3 DESIGN OF STRUCTURES, COMPONENTS, EQUIPMENT AND SYSTEMS

Section 3.1 of the William States Lee III Nuclear Station (WLS) combined license (COL) Final Safety Analysis Report (FSAR), Revision 11, incorporates by reference, Section 3.1, "Conformance with NRC General Design Criteria," of Revision 19 of the AP1000 Design Control Document (DCD). In addition, in the WLS COL FSAR, the applicant provided the following:

Figure 3.7.1.4-1 The WLS horizontal NI FIRS, the AP1000 horizontal certified seismic design response spectra (CSDRS), and the AP1000 horizontal hard rock high frequency spectra (HRHF). (Ref. WLS COL FSAR Revision 9, FSAR 3.7-201)

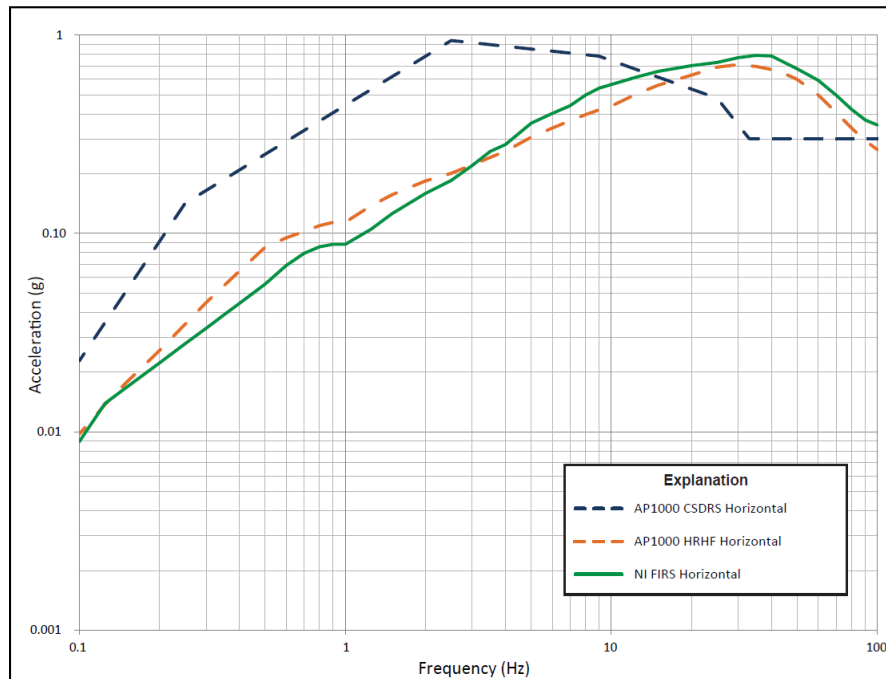
In WLS COL FSAR Section 3.7.1.1.1, the applicant described that it used the envelope of the Unit 1 and Unit 2 FIRS, referring to the enveloped spectra as NI FIRS. The resulting horizontal NI FIRS is shown in Figure 3.7.1.4-1 of this report and the vertical NI FIRS is shown in WLS COL FSAR Figure 3.7-202.

As shown in WLS COL FSAR Figures 3.7-201 (Figure 3.7.1.4-1 of this report) and 3.7-202, the horizontal NI FIRS exceeds the standard horizontal AP1000 CSDRS at frequencies above approximately 14 Hertz (Hz) and the vertical NI FIRS exceeds the CSDRS at frequencies above approximately 16 Hz. The peak ground acceleration (PGA) values for horizontal and vertical NI FIRS are 0.35g and 0.32g, respectively. The applicant also provided a comparison of the NI FIRS to the HRHF spectra. The horizontal NI FIRS exceeds the horizontal AP1000 HRHF spectrum above 3 Hz and the vertical NI FIRS exceeds the vertical HRHF at frequencies between about 3 and 55 Hz and between 80 and 100 Hz. The aforementioned exceedances of

the NI FIRS to both the CSDRS and the HRHF spectra are identified by the applicant as departure WLS DEP 2.0-1. To address this departure, the applicant stated that consistent with AP1000 DCD Section 2.5.2.1, paragraph 4b, a site-specific analysis of the AP1000 has been performed, similar to the analysis described in AP1000 DCD Appendix 3I, to demonstrate that the high frequency spectra exceedances are within the seismic design margin of the AP1000 certified design and will not adversely affect the structures, systems, or components of the plant.

Figure 3.7.1.4-2 The WLS horizontal NI FIRS and the staff's (NRC) horizontal NI FIRS

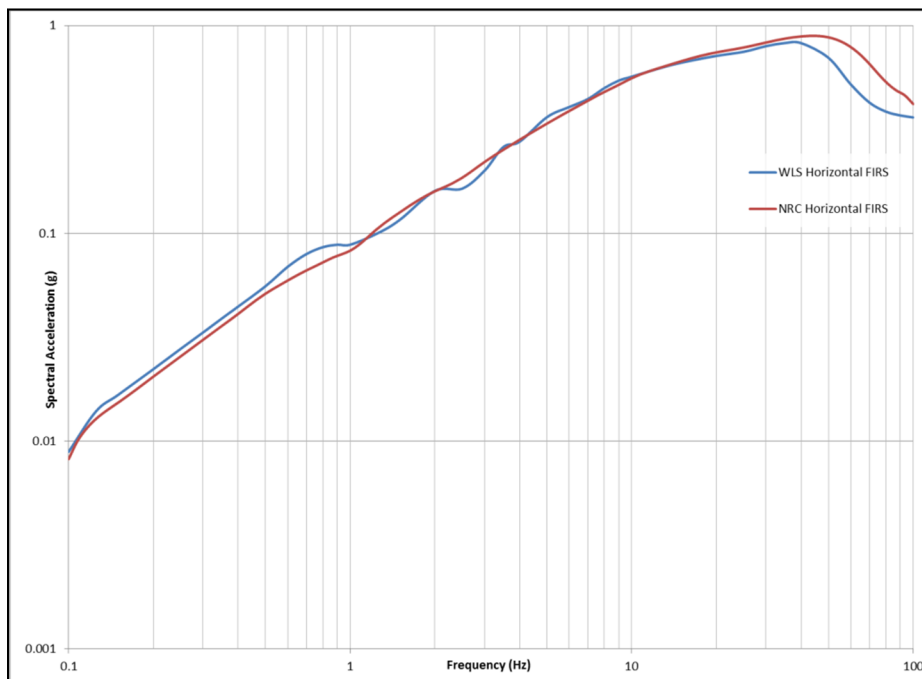
To determine the adequacy of the applicant's FIRS calculations, the staff completed confirmatory calculations. As input, the staff used the static and dynamic properties provided in WLS COL FSAR Section 2.5.4 and 2.5.2.7 for base cases A1, A5, and C4. To represent the input rock motions, the staff used the applicant's low- and high-frequency 10^{-4} and 10^{-5} rock spectra. The staff completed its site response calculations using the Strata software (Kottke and Rathje, 2008). The staff compared its calculated horizontal NI FIRS with the applicant's in Figure 3.7.1.4-2 of this report. Figure 3.7.1.4-2 of this report shows that the staff's NI FIRS calculation is similar to the applicant's NI FIRS across the frequency range typically important for engineering purposes (i.e., 0.5 to 10 Hz).

The staff noted a difference between the applicant's and the staff's NI FIRS results at high frequencies (between approximately 40 and 100 Hz). The staff noted the WLS FIRS amplification transfer functions show amplification from approximately 30 to 100 Hz due to the varying fill concrete beneath the WLS proposed structures, which means that at those frequencies the FIRS should have larger spectral accelerations than the WLS site-specific GMRS. In contrast, the WLS NI FIRS is less than the WLS GMRS at high frequencies. To investigate this issue, in RAI 118, Question 03.07.01-6, the staff requested that the applicant assess and evaluate the inconsistency of WLS FIRS amplification transfer functions, FIRS, and the GMRS and to provide a thorough description of the assessment and evaluation. The staff also requested that the applicant explain the basis and justify the conclusions regarding the relationship between the WLS site-specific amplification functions, FIRS, and GMRS.

In a July 24, 2014, response to RAI 118, Question 03.07.01-6, the applicant described that the noted differences in the relationships of the horizontal GMRS and FIRS are attributed to differences in high-frequency interpolation methods used to develop the rock (GMRS) and concrete (FIRS) spectral shapes. In Figure 3.7.1.4-3 of this report, the applicant presented the horizontal GMRS and FIRS A1 from WLS COL FSAR, Sections 2.5.2.6 and 2.5.2.7 (labeled as

Figure 3.7.1.4-3 Comparison of the horizontal GMRS and FIRS A1 from the FSAR (“Orig”) and horizontal GMRS and FIRS A1 using the methodology consistent with that used to develop the FSAR NI FIRS (“Altern”). (Ref. RAI 03.07.01-6 response Figure 9)

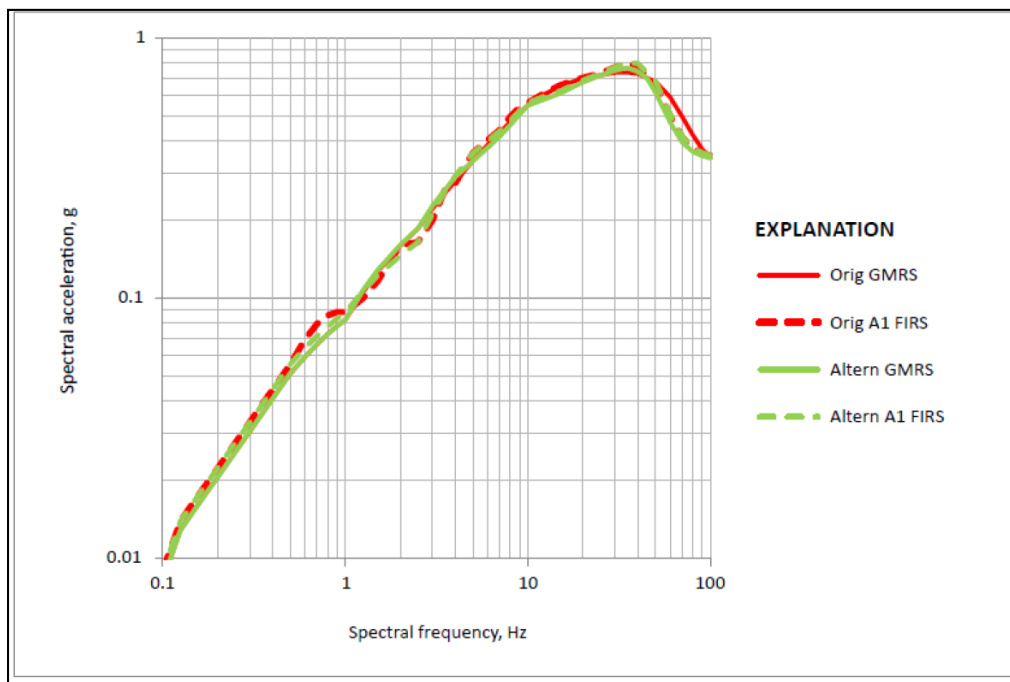
“Orig”) and compared them to alternative calculations of the horizontal GMRS and FIRS A1 based on the FIRS high-frequency interpolation method (“Altern”). The applicant’s RAI response results demonstrated that using the same interpolation methods lead to consistent spectral shapes and resulting in a GMRS that is generally lower than the GMRS presented in WLS COL FSAR Revision 9.

Based on this review, the staff concludes that the WLS COL FSAR Revision 9 horizontal GMRS and FIRS spectra are considered appropriate. Additionally, the staff also concludes that the difference in interpolation methods explains the differences between the WLS NI FIRS and the NRC NI FIRS shown in Figure 3.7.1.4-2 of this report. Accordingly, the staff concludes that the WLS NI FIRS satisfy the acceptance criteria of RG 1.208 and the requirements of 10 CFR 100.23, and considers RAI 118, Question 03.07.01-6 resolved. Based upon its review of WLS COL FSAR Section 2.5.2.7 and 3.7.1.1.1, the applicant’s response to RAI 118, Question 03.07.01-6, and the staff’s confirmatory analysis, the staff concludes that the applicant’s methodology and results for calculations of the site-specific NI FIRS are acceptable and resolved.
